Project Name: Elizabeth Lake Retail

Description: Rezoning Request & Preliminary Site Plan Approval

RE: White Lake Plaza- Preliminary Site Plan Review – 8th Review

RE: Elizabeth Lake Retail
Rezoning and Preliminary Site Plan – Review #9

SP-4

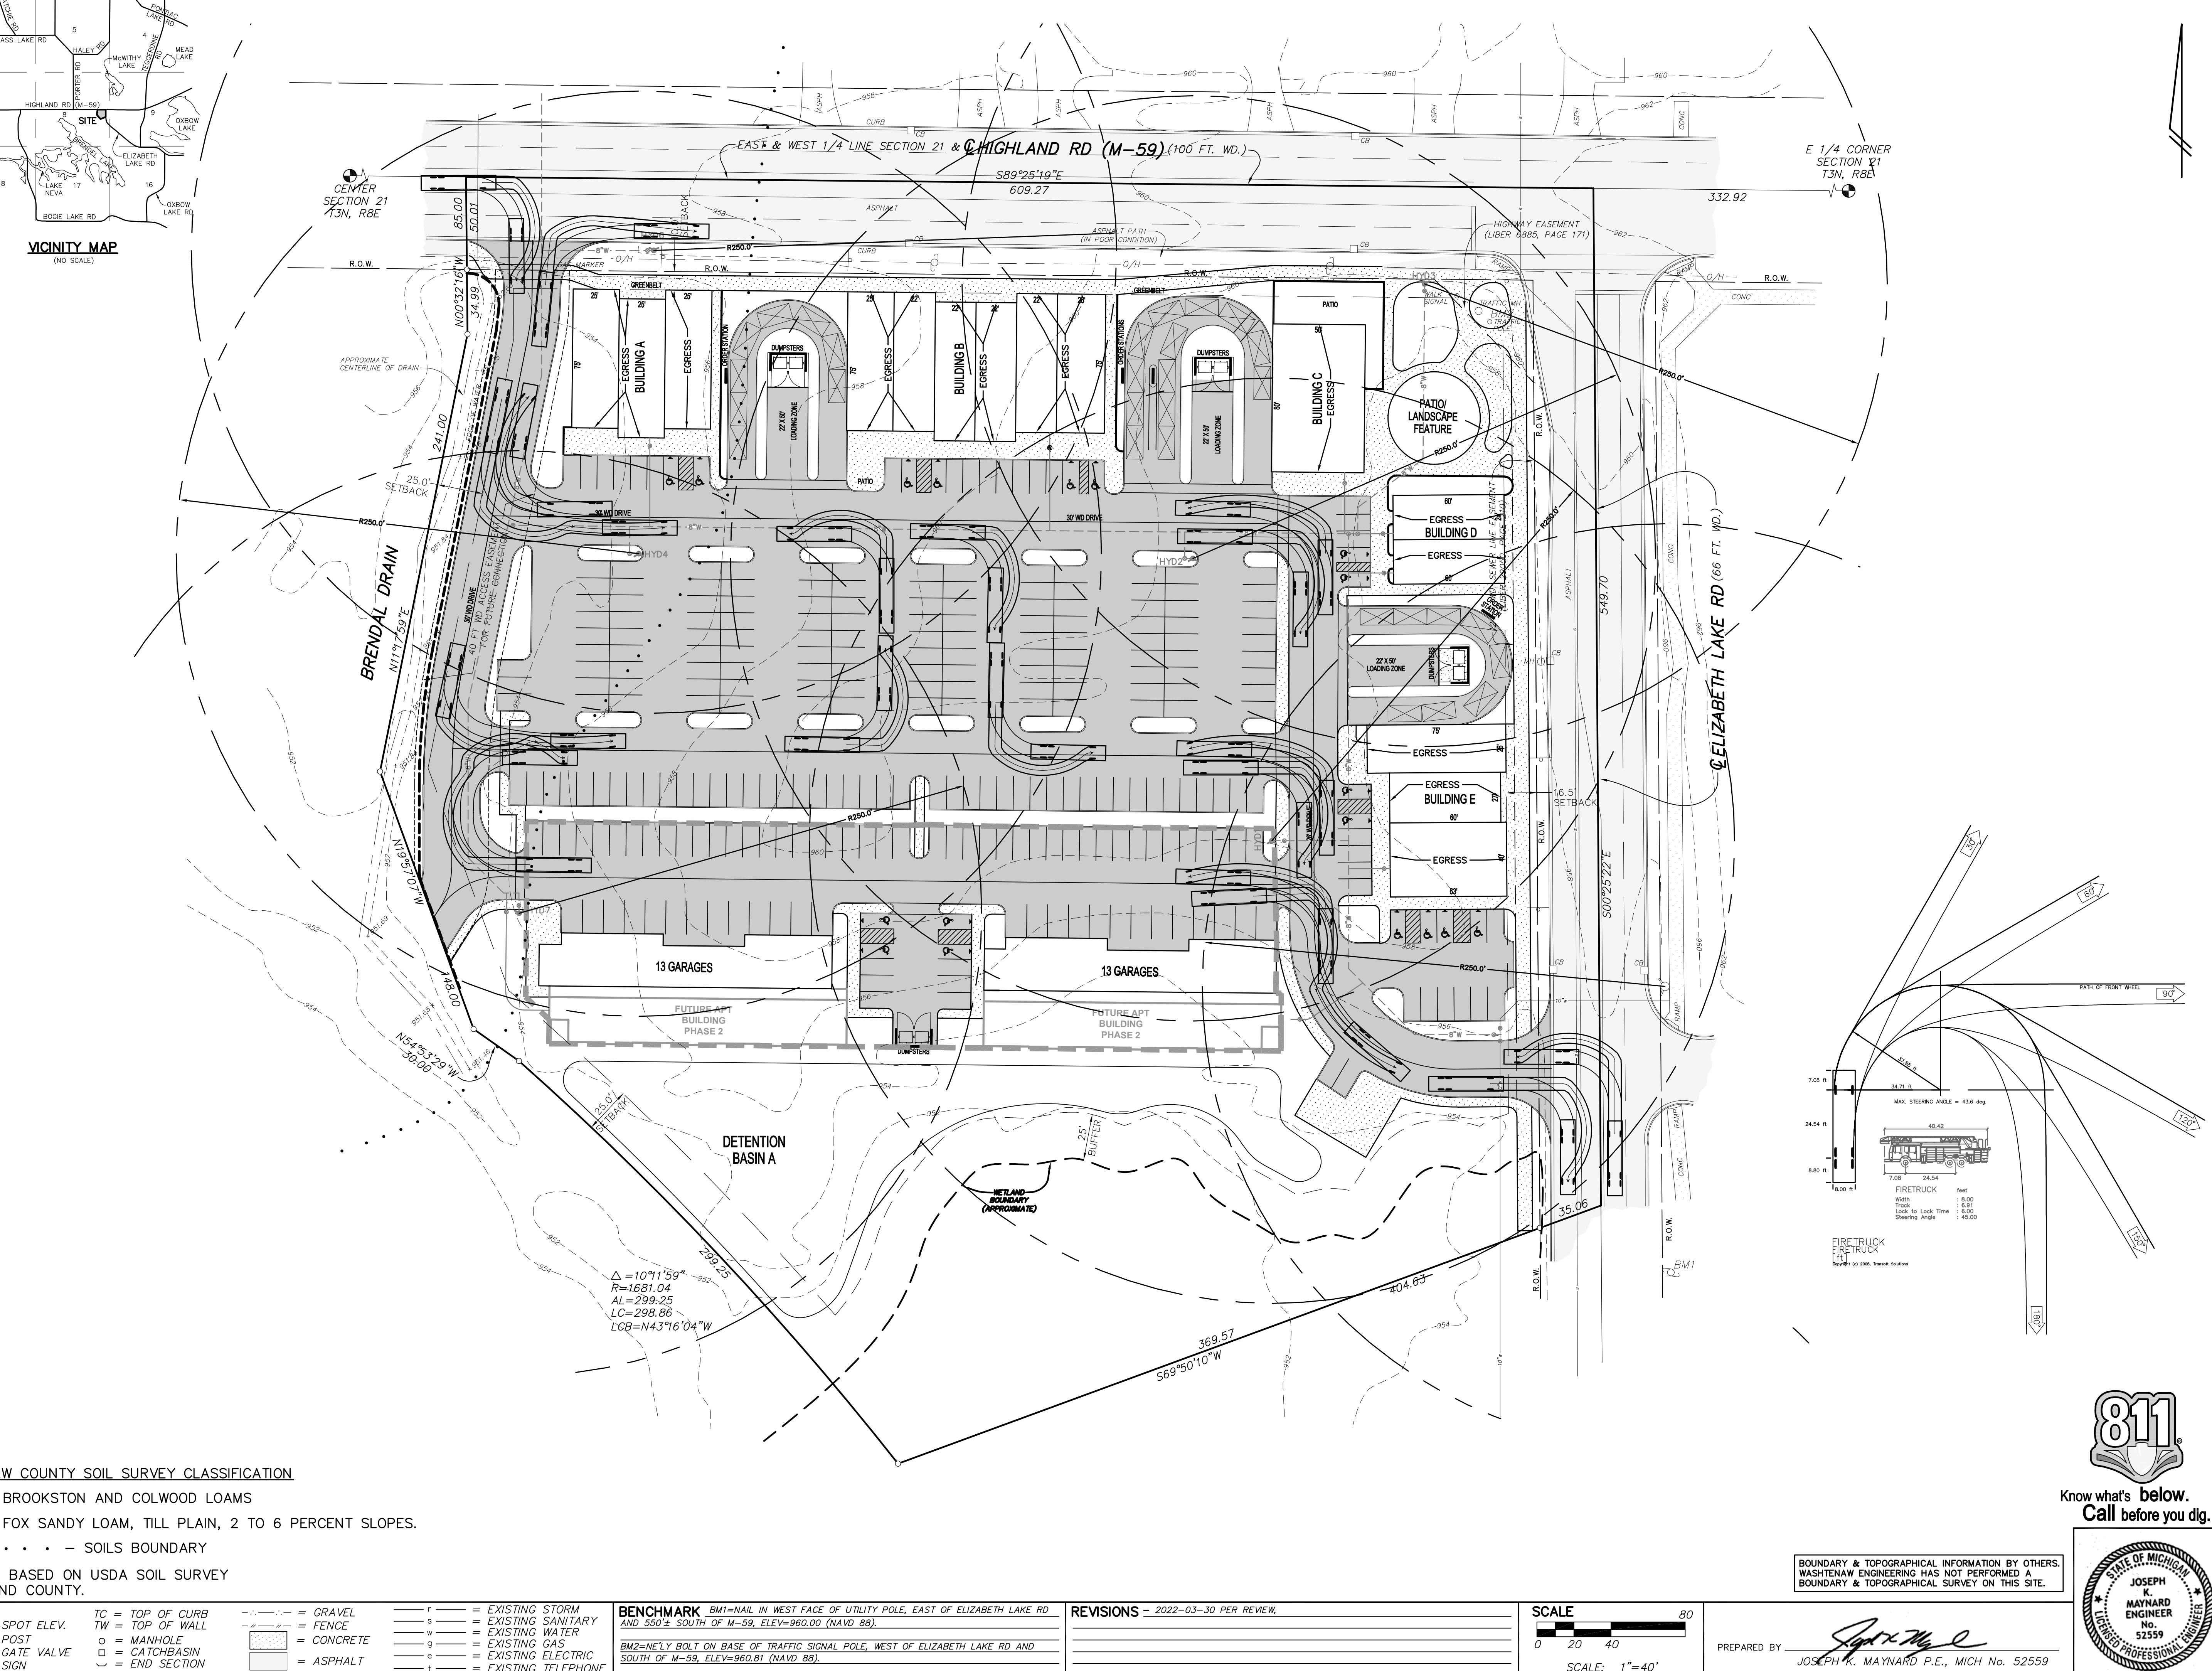
- c) *White Lake Township Fire Department has deferred further comment to this office regarding turning radius for fire apparatus. The plan sheet SP-4 shows a fire truck "dropped" onto the plan in several areas. This does not sufficiently demonstrate space required for the turning movements. This is typically accomplished with AutoTURN software to show the required path of travel for a 40-foot-long vehicle to navigate the site. Please update the plans to show the path of travel required for a 40-foot vehicle to navigate the site. We also note there are outstanding items on the Fire Department review regarding fire hydrant coverage and placement. Turning movements for fire apparatus have been provided on the plan set. Note that the traffic sign near the drive thru exit of Building C will need to be relocated as it will be damaged by the movements. New layout shows turning movements and radii for a fire truck. Clarification will be required regarding the proposed drive slope on the Highland Road approach to demonstrate the angle of approach will not cause clearance issues with fire apparatus. DLZ continues to defer comment to the Fire Department regarding fire hydrant coverage as the on-site hydrant proposed may be difficult to access in proposed location. **Comment remains as a notation. An updated turning radius has now been provided to clearly show all turning movements for a fire truck. Hydrant locations have also been updated and we continue to defer to the Township Fire Department with respect to hydrant coverage.***
